posard broek + associates

RE: 7 Highgate Court, Kensington, CA 94707  
PB+A Review of "Appeal of Development Plan Approval for the Remodel at 7 Highgate Court, Kensington" & related documents.

MARCH 1, 2018 "REV DEV PLAN" (MOST PAGES STILL DATED 10/25/17 "DEVELOPMENT PLAN")

65 Highgate Road: current seated view

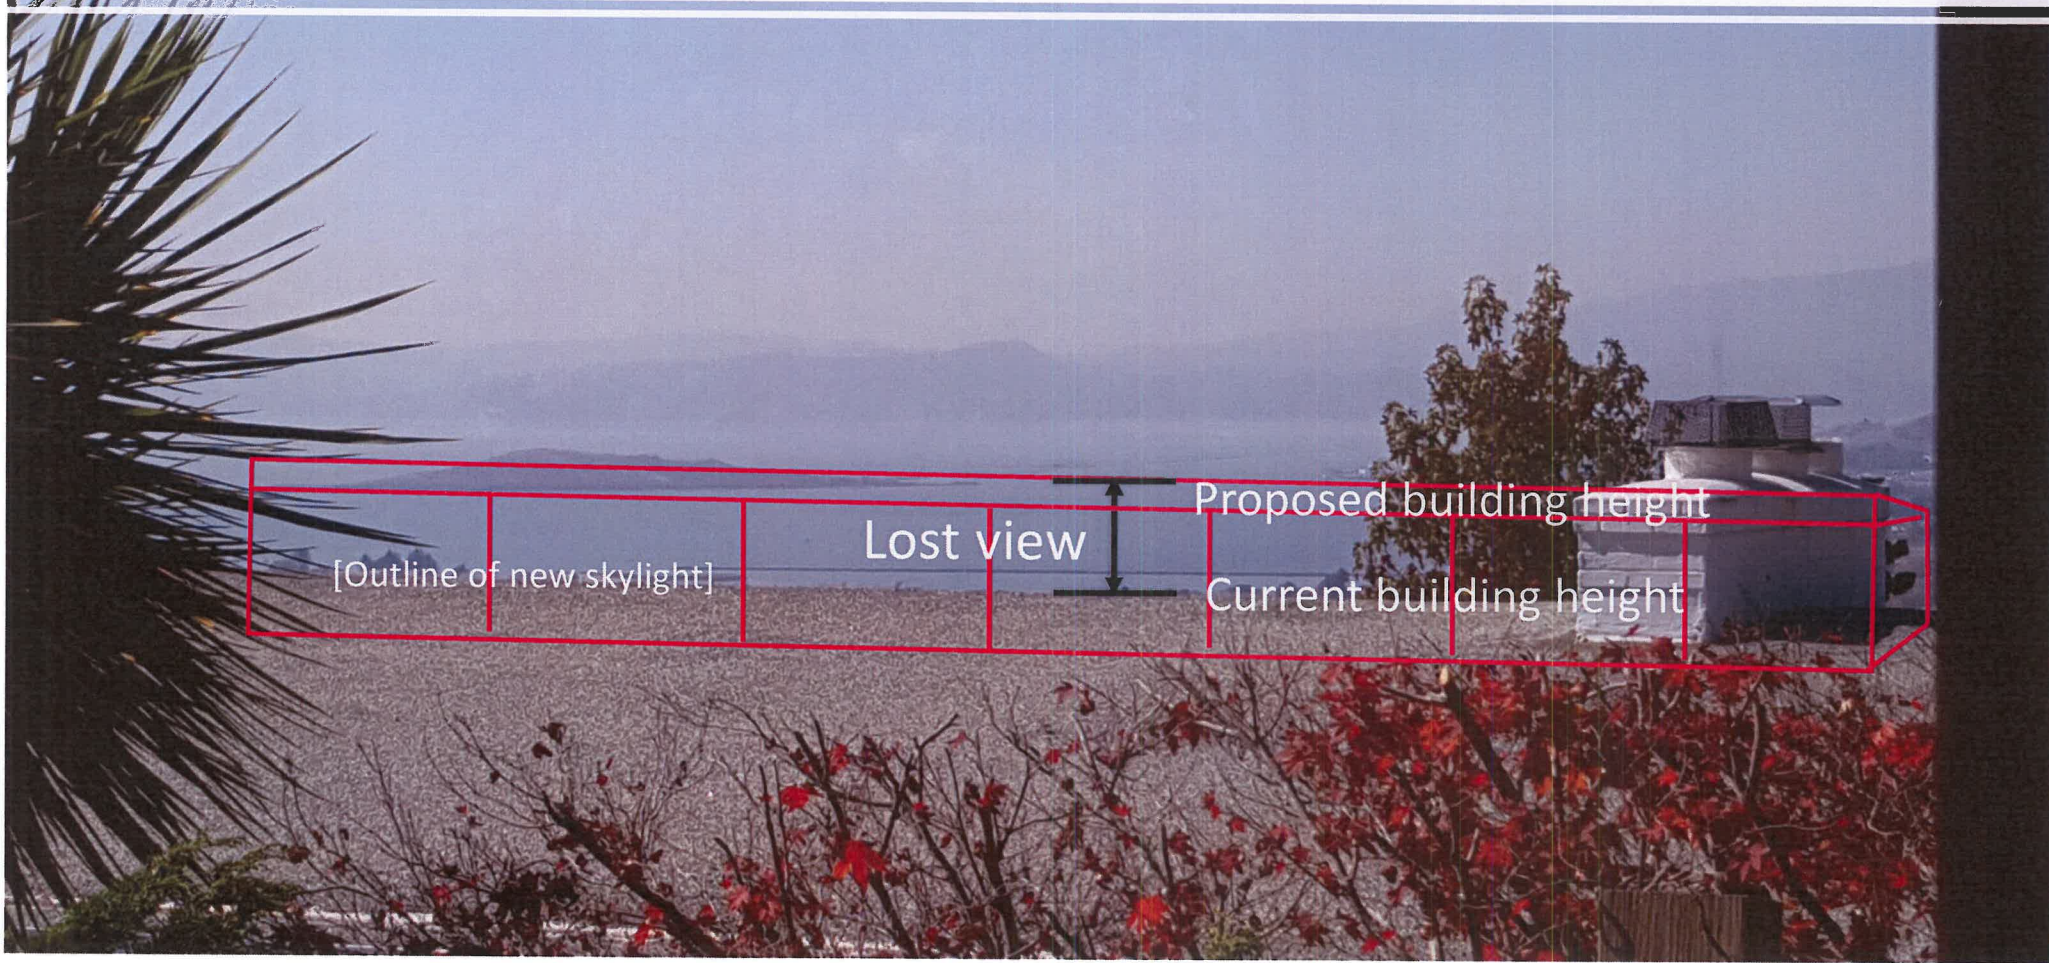
2. The proposed design will impact both the quantity and the quality of the seated view from 65 Highgate Court. It will not only take away a significant portion of the view of the bay, but it will also obscure most of Brooks Island, a scenic natural feature that also holds historical personal significance for the Owner.

# View loss due to height increase at 7 Highgate Court

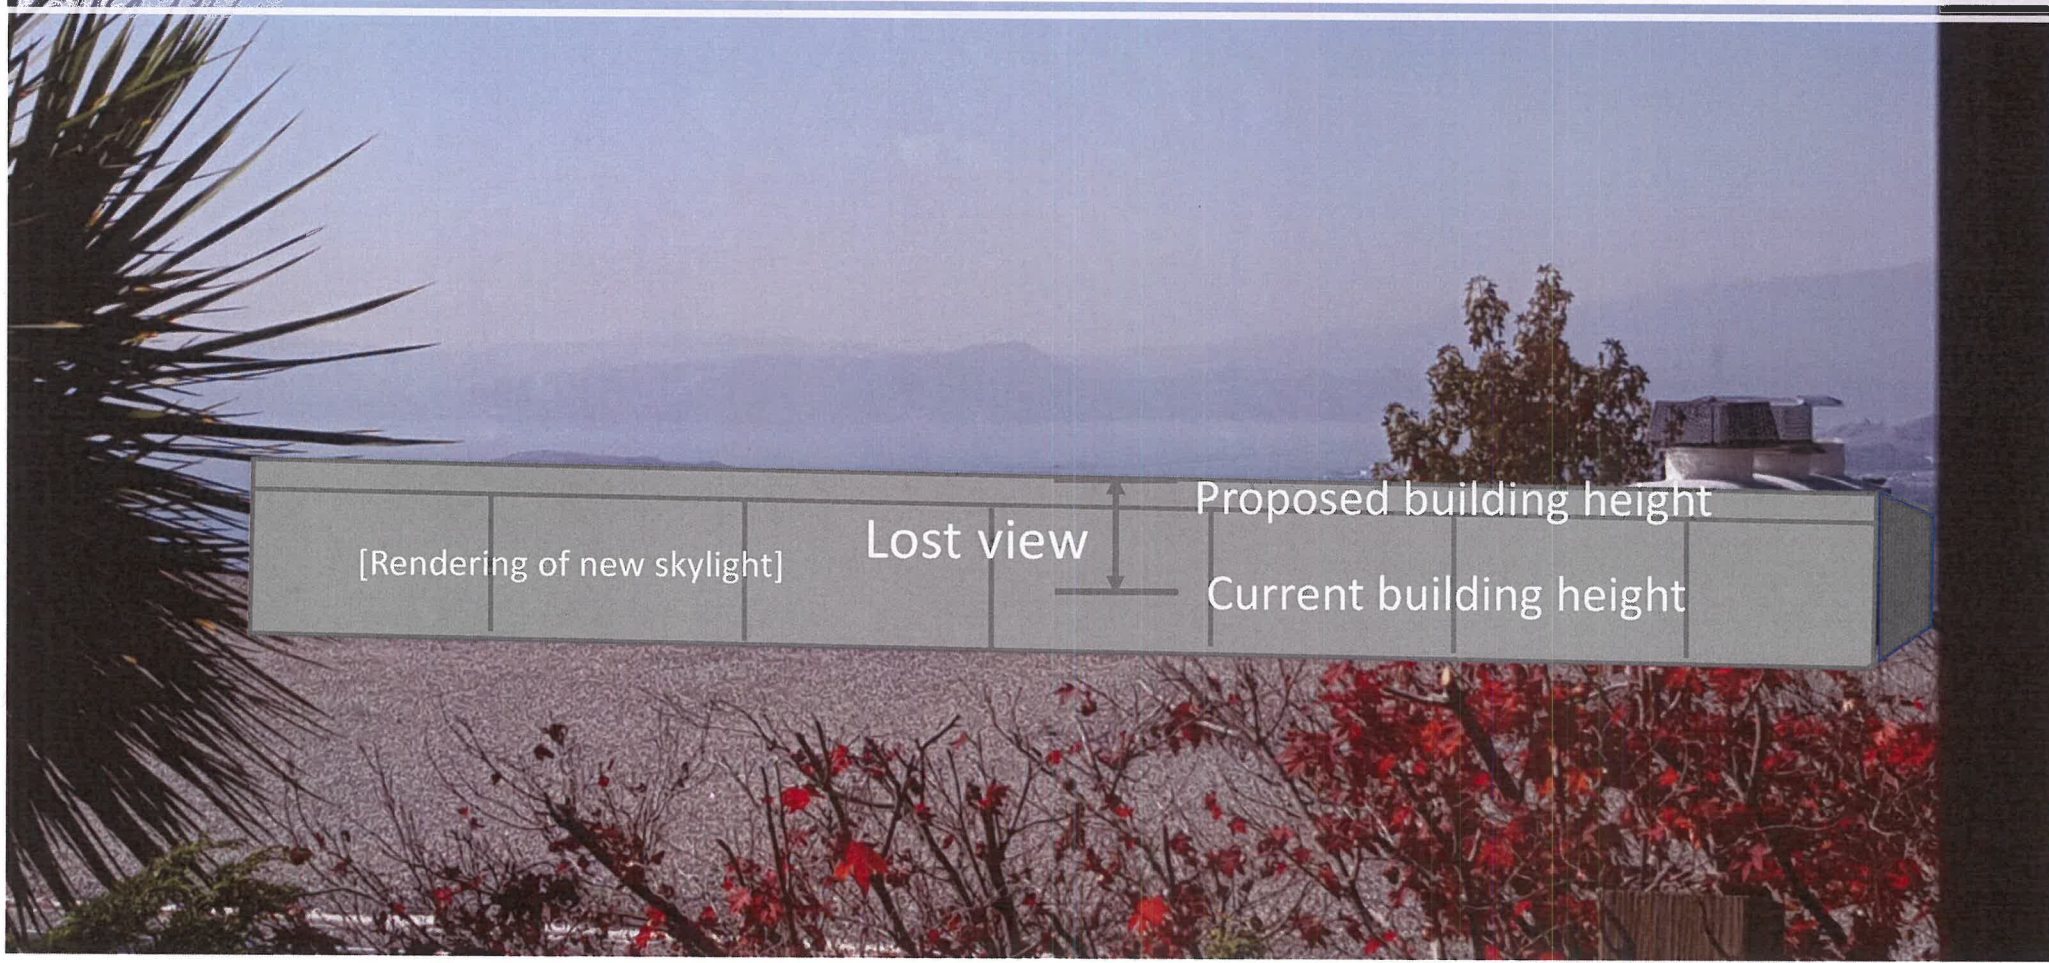
2. The new skylight height is called out as 1'-6" above the NEW ridgeline.
3. Taken together, this represents a total 22" – 24" increase to the building height.

Lost view

Proposed building height

Current building height

# Rendering of light pollution from new skylights

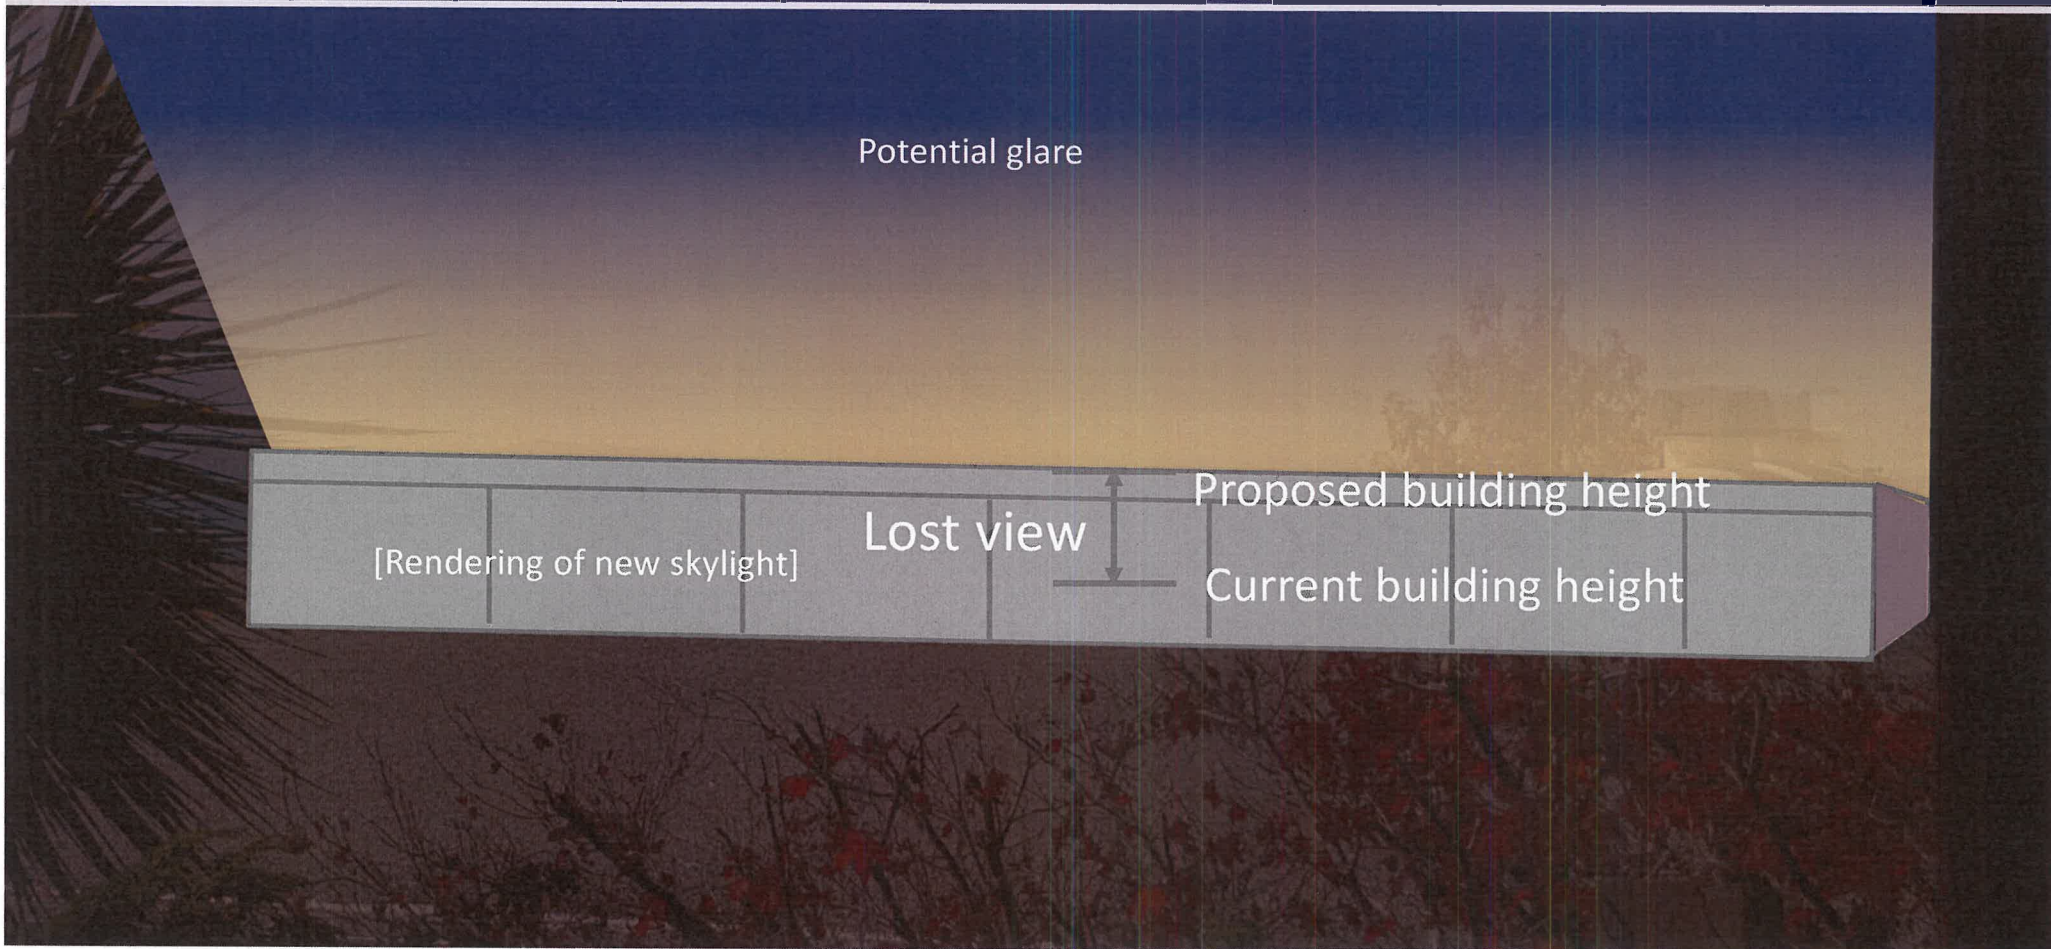
10. The size and orientation of the 23' long skylight in particular will undoubtedly create glare/ light pollution, significantly impacting the nighttime view from 65 Highgate Road.

1. The staff report makes no mention of light pollution—the glare from the new skylights that threatens to ruin the nighttime view from 65 Highgate Court.

## Skylight Shading Options

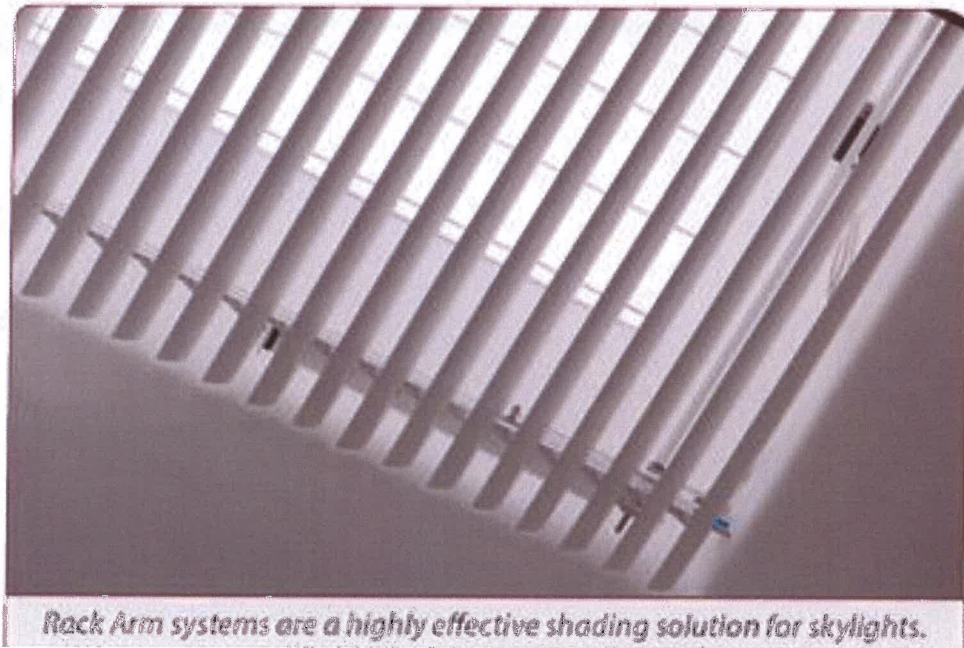
6. The applicant plans to add shades to the skylights, and has stated that this is a concession that was made due to decreasing the depth of the skylights. However, it is the case that the 23' long skylight would have required shades regardless of its depth. Since shades must be included for the 23' long skylight, there is no reason why the skylight cannot be of standard height.

7. Choosing an opaque skylight, or an opaque lay-light below the skylight, would cut down on direct sunlight issues while maintaining the view from 65 Highgate Road.
